Expert Opinion Report - Rectification

10-12 View Point Road, McCrae

PSM5226-005R 11 June 2024

Inset 2: Excerpt from CivilTest report 1222044-1 Issue 2 (5 December 2022) (Document 2, pdf page 4)

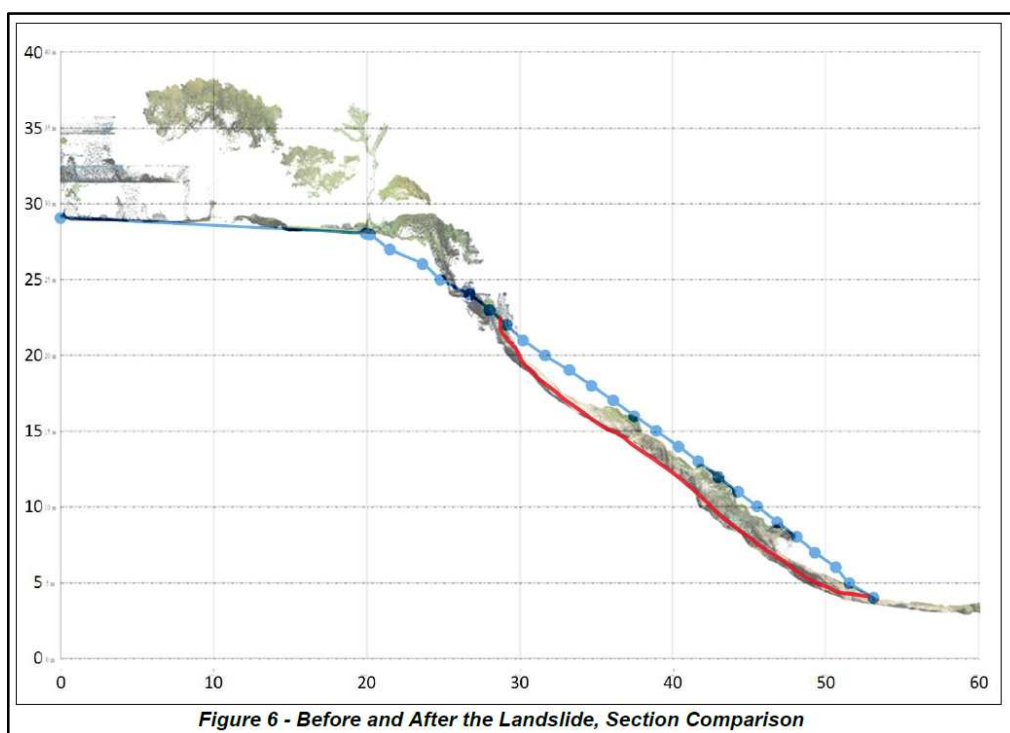
- (d) The steep head scarp depicted in CivilTest drone survey (Inset 2) and models (ref) is an artefact of creating a thick cross section line from the drone model. i.e. the head scarp feature depicted by CivilTest at the crest of the escarpment does not exist on Site (refer to Paragraph [9(a)]).

- (a) The CivilTest drone survey shows an over-steepened back scarp that was not observed during the Site visit.
 - (b) The feature survey contours show possible inaccuracies in the middle and lower slopes, with an overall convex slope profile that is inconsistent with the concave slope profile observed during the Site visit.

Inset 3: CivilTest description of debris flow as “fill” (Document 9, pdf page 3)

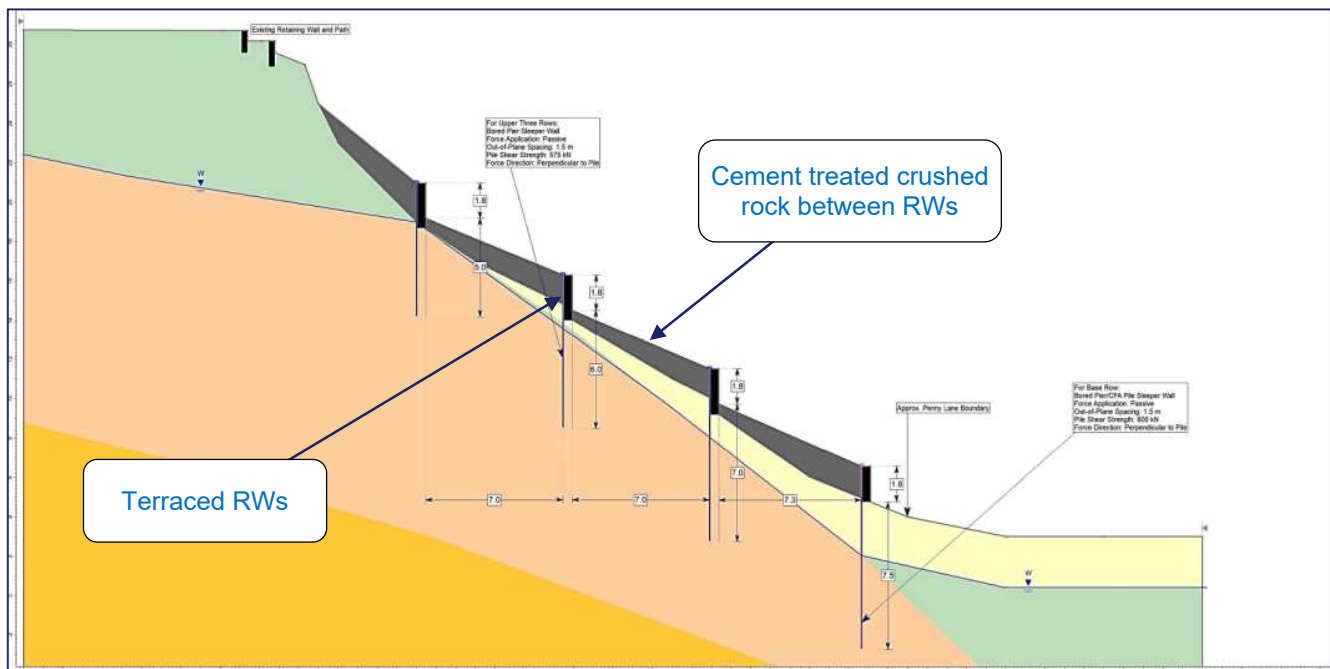
10. Documents 9 of the Brief is the CivilTest Land Stability Assessment report 1222044-3 (24 March 2023). The report indicates to me:
- (a) Boreholes drilled at the toe of the slope in Penny Lane encountered landslide debris, Inset 3 (Section 2.1, pdf page 3).

- (b) Boreholes 1 and 2 encountered landslide debris 1.2 m and 0.7 m thick respectively (Appendix C, pdf pages 29 to 30). I have assumed that all fill reported at the toe of the slope is landslide debris.
